# **Assessment of Newfoundland and Labrador Hydro's 2024 Resource Adequacy Plan**

**Presented to:  
Newfoundland and Labrador  
Board of Commissioners of Public Utilities**

August 30, 2024

**Figure 6: Population data comparison**

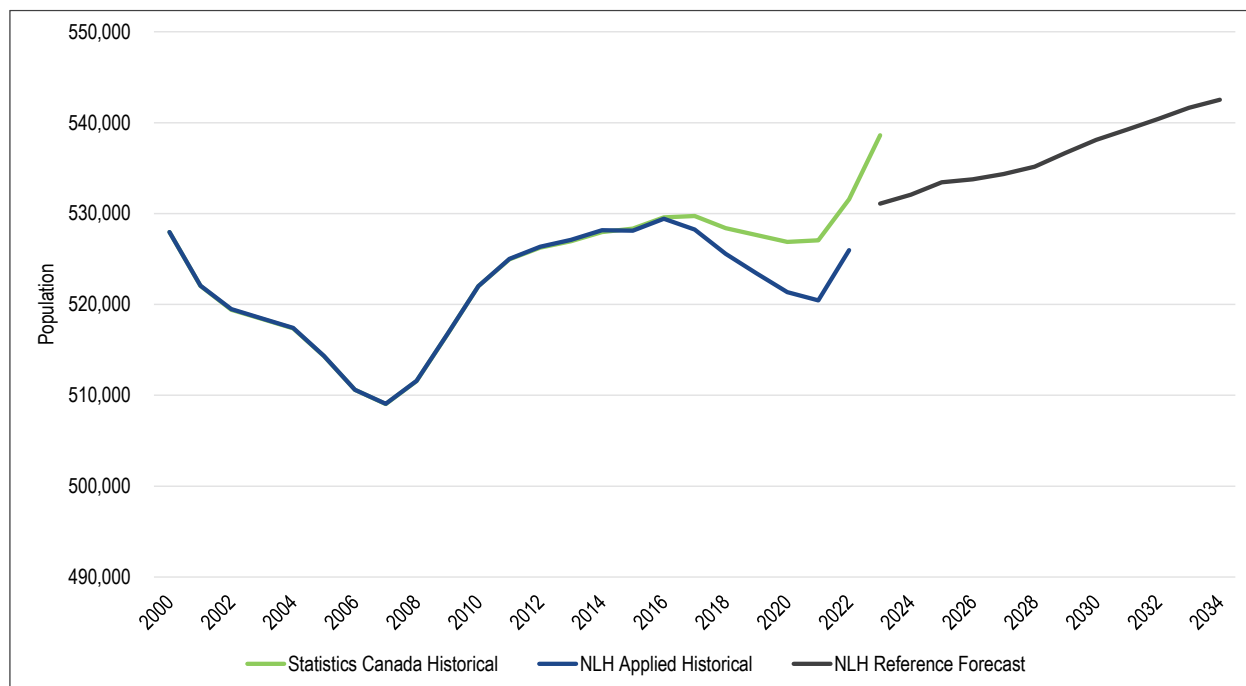
Another issue of concern relates to the range of population projections applied by NLH in its load forecasts. All three of the NLH cases anticipate positive population growth. In contrast, Statistics Canada has a much wider range of forecast cases for the province. Figure 7 shows a comparison of the three NLH population growth series and the three main forecasts from Statistics Canada.<sup>110</sup>

**Figure 7: Comparison of population forecast cases, Statistics Canada and Newfoundland and Labrador Finance Department**

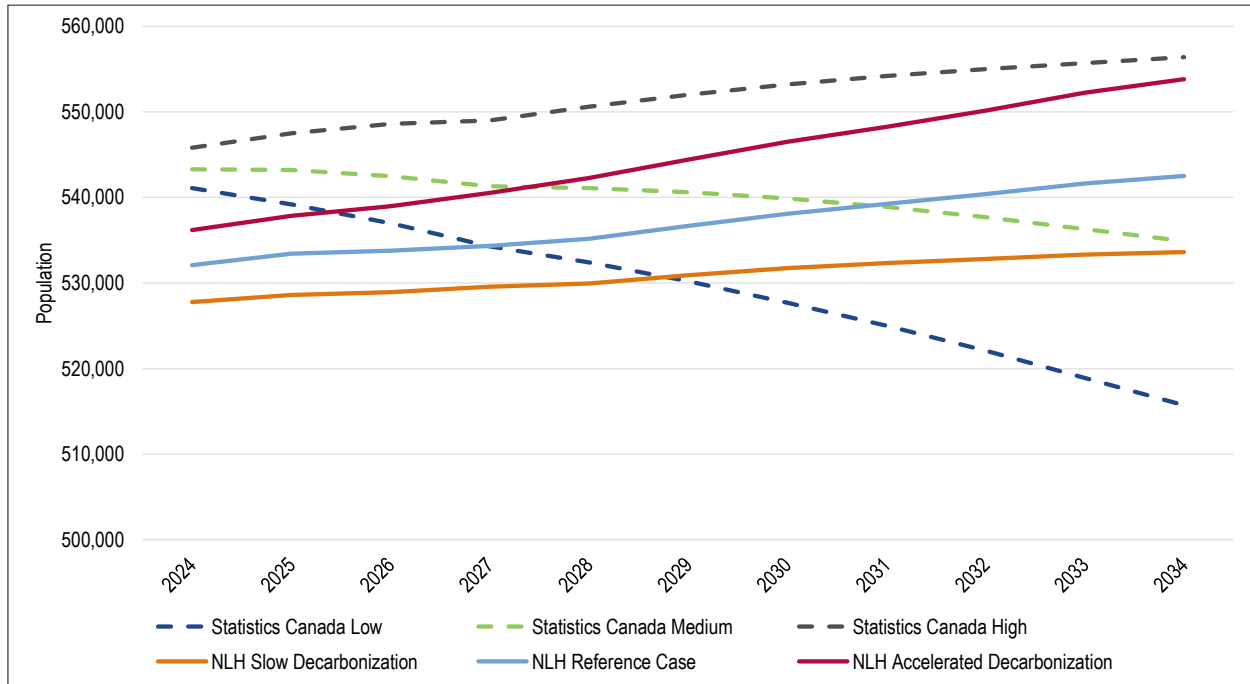
Based on the historical data discrepancy issue described above, there may be a difference in the implicit starting point of the two forecasts. Regardless, it is clear that the Statistics Canada cases have a much wider range of futures – two of which show falling population between 2024 and 2034. The NLH cases cluster closer together and provide less distinction between potential futures. Bates White concludes that NLH should provide a fuller discussion and justification for the selection of the given population cases applied in its load forecasts. In general, it would be more useful to have a wider range of cases. One option would be to adopt cases from the Statistics Canada forecast set, which, in addition to the three main cases shown in Figure 7, include seven other population cases.

**Figure 8: Comparison of Population and Residential Customer Count Growth Rates<sup>111</sup>**

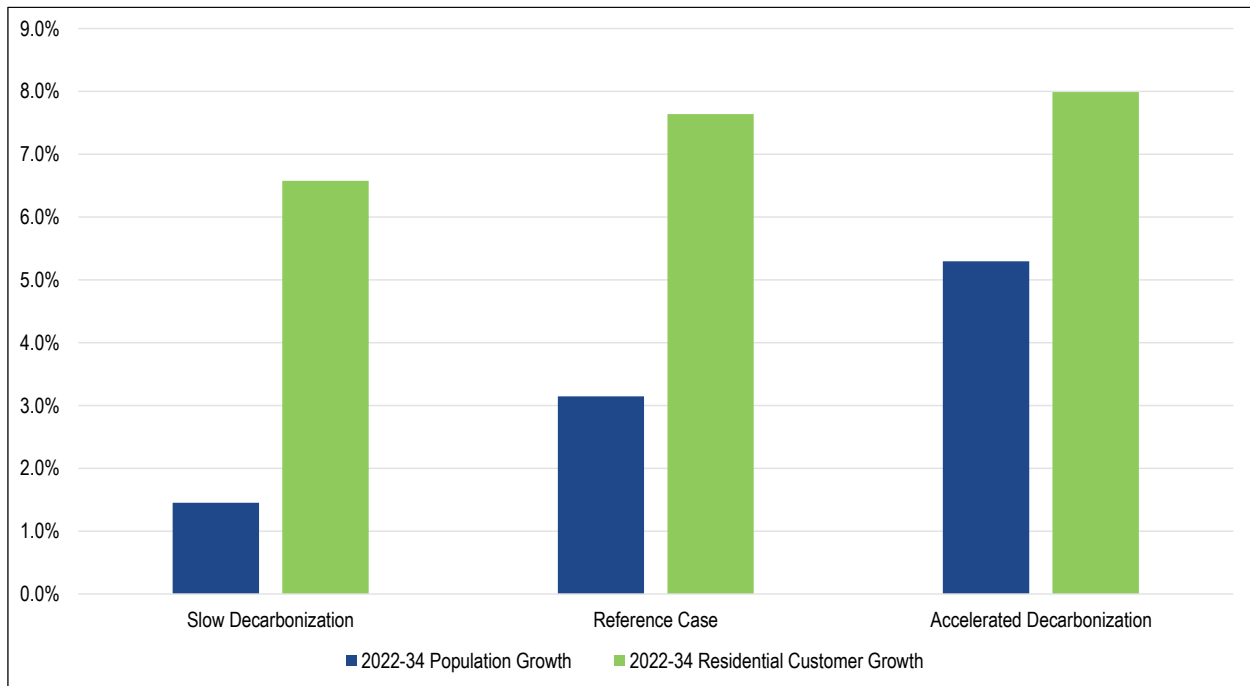
A final observation related to population is that residential customer count grows significantly faster than population in the NLH projections. This is significant as customer count is more relevant to load than population estimates. The percent changes for population and IIS residential customer count from 2022 to 2034 used in the NLH forecast data are shown in Figure 8.

This higher growth rate for customer count compared to population reflects a long-term trend in which residential customer count as a share of total population has grown significantly over time. In 1977, IIS residential customer count as a percentage of total population was about 23%, and by 2022 it had grown to 49%.<sup>112</sup> This may reflect demographic changes, including an aging population (with fewer children at home) migration from rural to urban areas, decreased birth rates (more people living singly or as a couple with no children). However, this trend continues through the forecast period, and it is important to note that the historical trend cannot continue without end. At some point, changes in customer count will align more closely with population growth, or contraction.
